Consolidation Coal Company  
Western Region  
2 Inverness Drive East  
Englewood, Colorado 80112  
(303) 770-1600

RE: Technical Review Responses  
Emery Deep Mine  
ACT/015/015, Folder No. 2  
Emery County, Utah

Addendum Response to comment UMC 784.14(c)  
(Ground-water inflow and drawdown effects)

FIGURE 1.  
 AREAL OVERVIEW OF THE EMERY  
 MINE SHOWING CONOSIM REGION

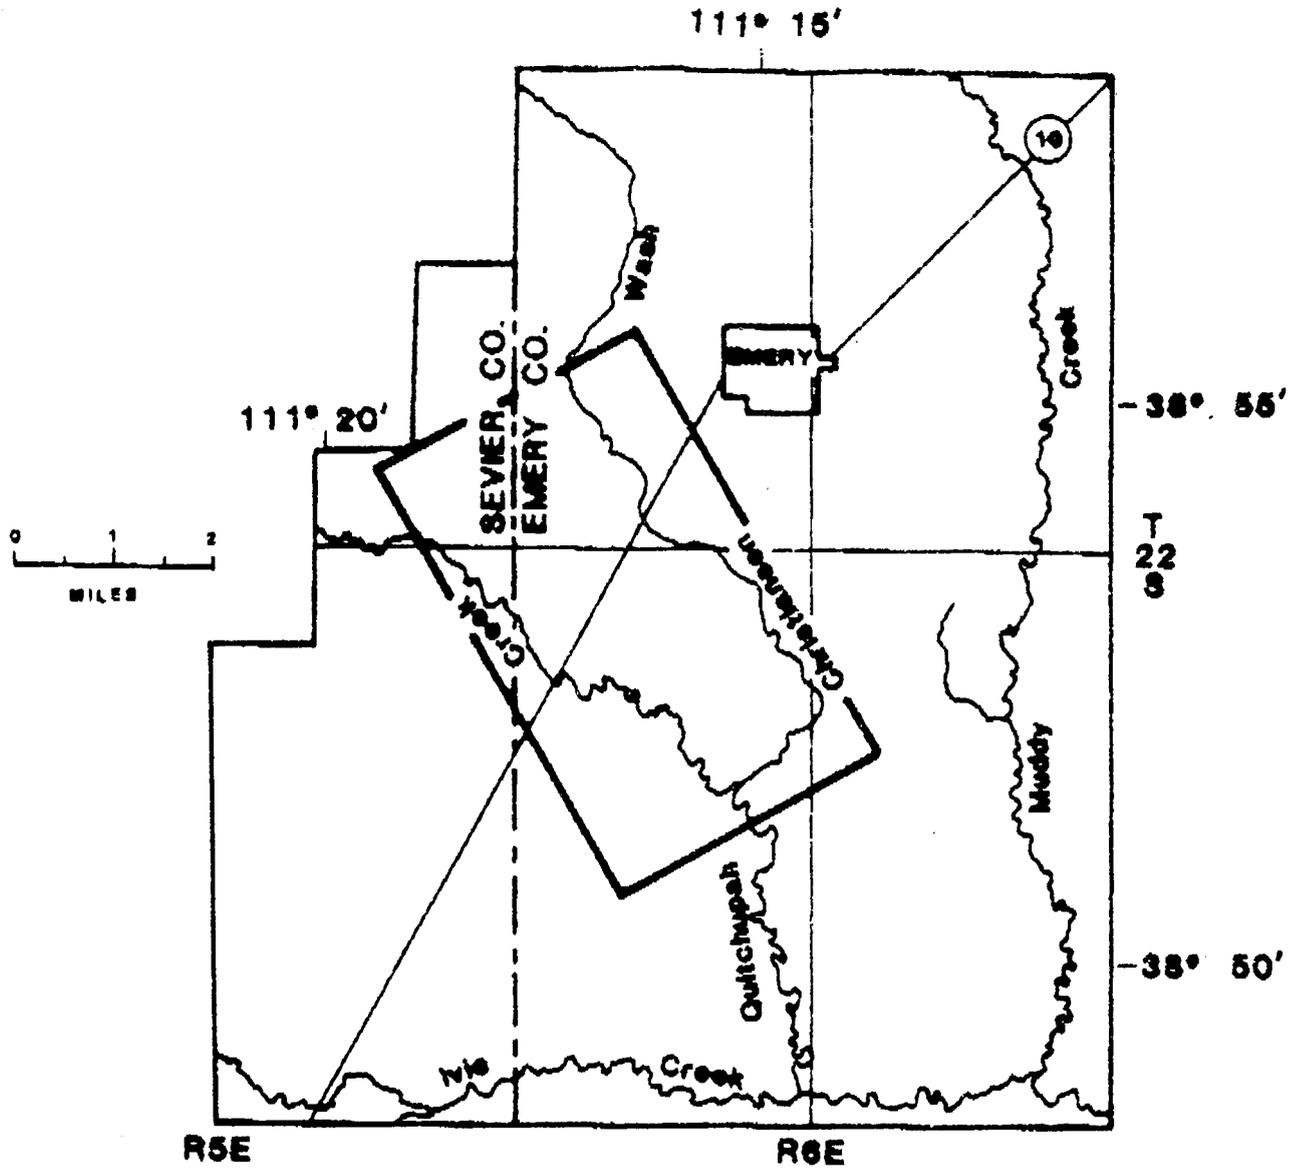
In order to evaluate the reasonableness of the model results, the applicant should provide a narrative which explains the assumptions, boundary conditions, calibration values and other pertinent information which were utilized in the stimulation. At this time, sufficient information to evaluate and verify the CONOSIM results has not been provided.

The map in Figure 1 shows the modeled area bounded by heavy lines. This area is approximately three by five miles in extent and includes the present and future mining areas.

BOUNDARY TYPE 1 represents constant pressures or constant flow grid nodes. With reference to Figure 1, these nodes occur along the northwestern boundary (located at the graben).
